Attachment: Response to NRC Request for Additional Information – Proposed License Amendment Request - Extension of TS 3.14 Service Water Flow Path Allowed Outage Time

Virginia Electric and Power Company
(Dominion)
Surry Station Units 1 and 2

RESPONSE TO NRC REQUEST FOR ADDITIONAL INFORMATION
SURRY POWER STATION UNITS 1 AND 2

Figure 1 – Simplified drawing of Service Water supplied to the Charging Service Water and MCR Chiller Service Water subsystems in MER 3, MER 4, and MER 5

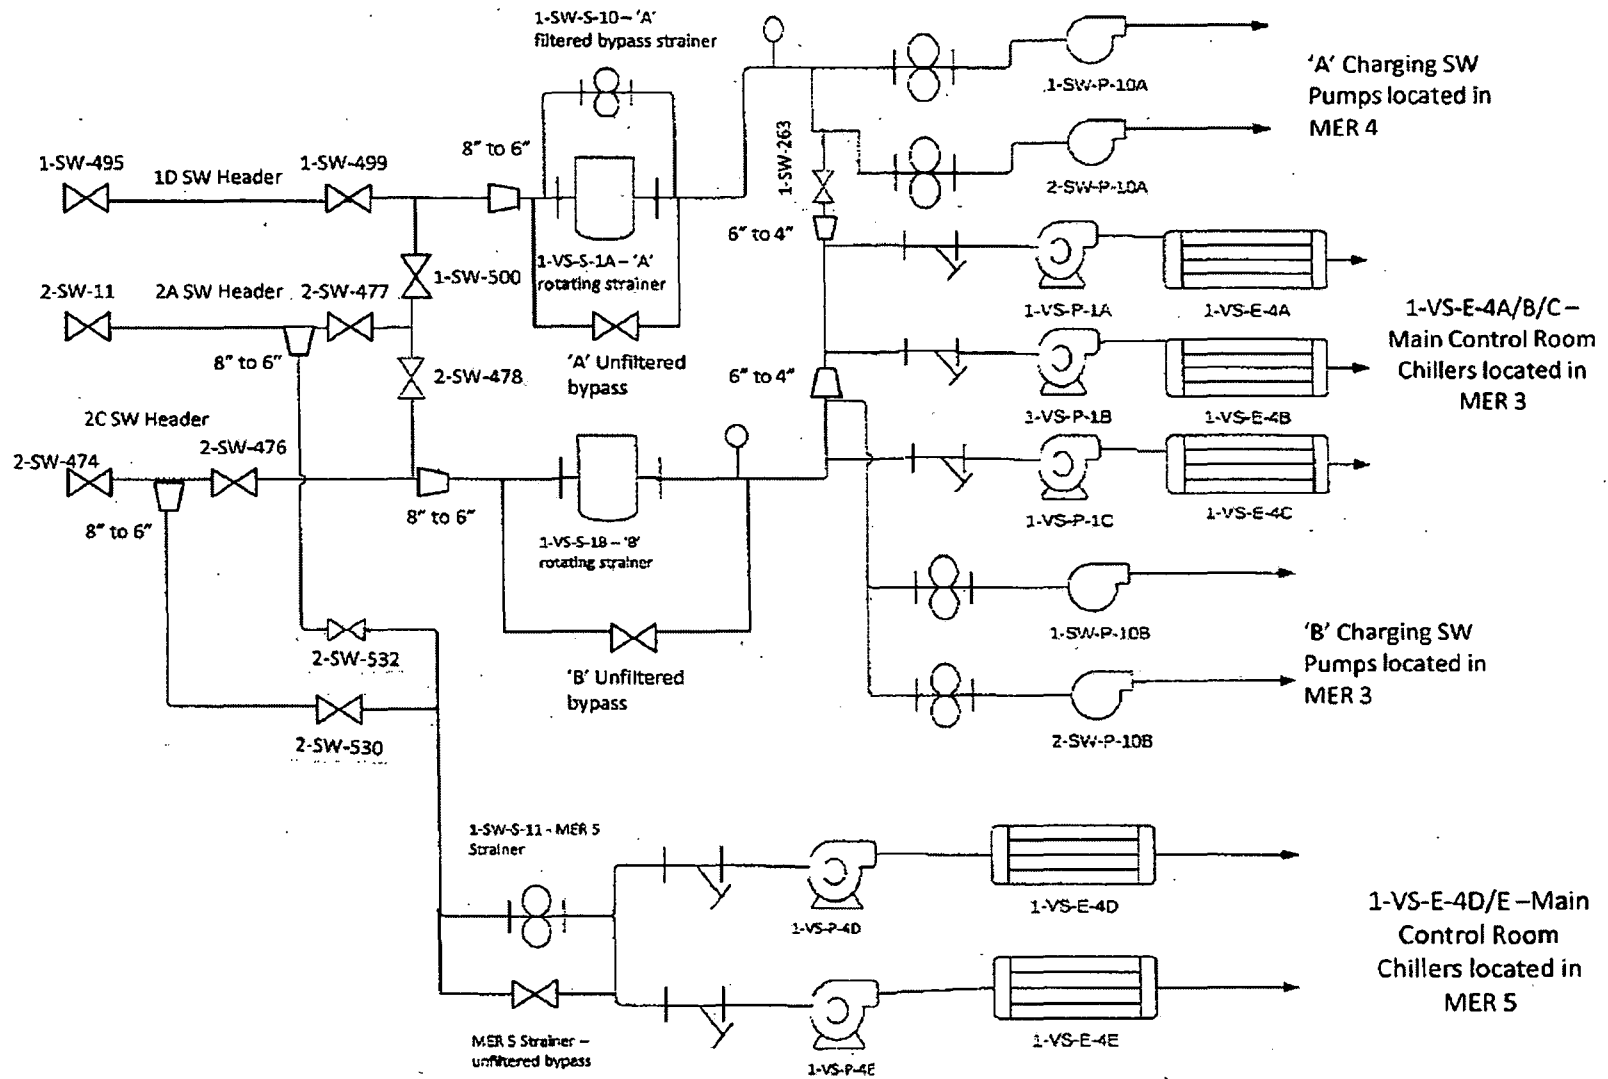
TS 3.14.7.A.7 requires that two service water flow paths to the main control room and emergency switchgear room (MCR/ESGR) air conditioning subsystems be OPERABLE. With five chillers in the MCR/ESGR Air Conditioning System, TS 3.23.A requires three MCR/ESGR chillers be OPERABLE in certain required combinations (NRC staff computes 6 possible combinations that meet the requirements TS 3.23.A.1.b). Neither the TS basis nor the UFSAR define what constitutes a service water flow path to a MCR/ESGR air conditioning subsystem which meet the requirements of TS 3.14.7.A.7 nor do they explain what constitutes a MCR/ESGR air conditioning subsystem.

- A) Define the bounds of a MCR/ESGR air conditioning subsystem specified in TS 3.14.A.7 and describe the relationship between the MCR/ESGR air conditioning subsystems and the MCR/ESGR chillers referenced in TS 3.23.A.*
- B) Define what constitutes a service water flow path to a MCR/ESGR air conditioning subsystem which meet the requirements of TS 3.14.7.A.7.*

- A. *For each allowed combination of 3 OPERABLE chillers (NRC staff computes 6 possible combinations which meet the requirements TS 3.23.A.1.b) and each applicable MCR/ESGR subsystem identify all acceptable combinations of two service water flow paths that meet the requirements of TS 3.14.A.7.*

B. While meeting the limiting conditions for operations of TSs 3.14.A.7 do any credited two service water flow paths to any MCR/ESGR subsystem, have any common components or piping. Explain. If so, provide further justification for extending the AOT from 24 hours to 72 hours, specifically addressing redundancy and independence of the two service water flow paths.

C. Can any single failure in the identified service water flow paths in B above cause more than one Chiller subsystem to be INOPERABLE? If so, provide further justification for extending the AOT from 24 hours to 72 hours, specifically addressing redundancy and independence.

- A. Identify all acceptable combinations of two service water flow paths that meet the requirements of TS 3.14.A.5.*
- B. While meeting the limiting conditions for operations of TSs 3.14.A.5, do any credited two service water flow paths to any charging pump service water subsystem, have any common components or piping. Explain. If so, provide further justification for extending the AOT from 24 hours to 72 hours, specifically addressing redundancy and independence of the two service water flow paths.*

Figures 1 and 2 show the Service Water (SW) supply to the Charging Pump Service Water (CPSW) subsystems located in Mechanical Equipment Room (MER) 3 and MER 4 and to the Main Control Room/Emergency Switchgear Room Air Conditioning (MCR/ESGR AC) subsystems located in MER 3 and MER 5.

The three 8-inch SW flow paths to the MCR/ESGR AC subsystem (referred to in UFSAR Section 9.9.2) are the 1D, 2A, and 2C SW supply headers to valves 1-SW-499, 2-SW-477, 2-SW-476, 2-SW-532, and 2-SW-530. Two of the three 8-inch SW headers (i.e., 1D and 2A, 1D and 2C, or 2A and 2C) are normally in service. The three 8-inch headers supply SW to two 6-inch headers to MER 3 and MER 4 and to two 6-inch lines to MER 5.

As can be seen in Figures 1 and 2, the flow paths available to supply SW to the MER 3 chillers are the following:

The three 8-inch SW flow paths to the MCR/ESGR AC subsystem (i.e., the 1D, 2A, and 2C SW supply headers to valves 1-SW-499, 2-SW-477, 2-SW-476, 2-SW-532, and 2-SW-530) have no common components or piping. However, as shown in Figures 1 and 2, there is common 6-inch and 4-inch piping within the MCR/ESGR AC subsystem. Although there is common piping within the MCR/ESGR AC subsystem, the AOT extension from 24 to 72 hours is acceptable based on the significant defense in depth for the chillers and the flow paths to supply SW to the MER 3 and MER 5 chillers. It

As shown in Figures 1 and 2, the three 8-inch SW flow paths to the CPSW subsystem (referred to in UFSAR Section 9.9.2) are the 1D, 2A, and 2C SW supply headers to valves 1-SW-499, 2-SW-477, and 2-SW-476. The three 8-inch headers supply SW to two 6-inch headers to MER 3 and MER 4.

As can be seen in Figures 1 and 2, the flow paths available to supply SW to the MER 3 and MER 4 100% capacity CPSW pumps are the following:

The three 8-inch SW flow paths to the CPSW subsystem (i.e., the 1D, 2A, and 2C SW supply headers to valves 1-SW-499, 2-SW-477, and 2-SW-476) have no common components or piping. However, as shown in Figures 1 and 2, there is common 6-inch piping within the CPSW subsystem. As stated in the Response to RAI-2 B), the MCR/ESGR AC subsystem and the CPSW subsystem share common components (i.e., the 6-inch headers and the rotating strainer lines/bypasses).
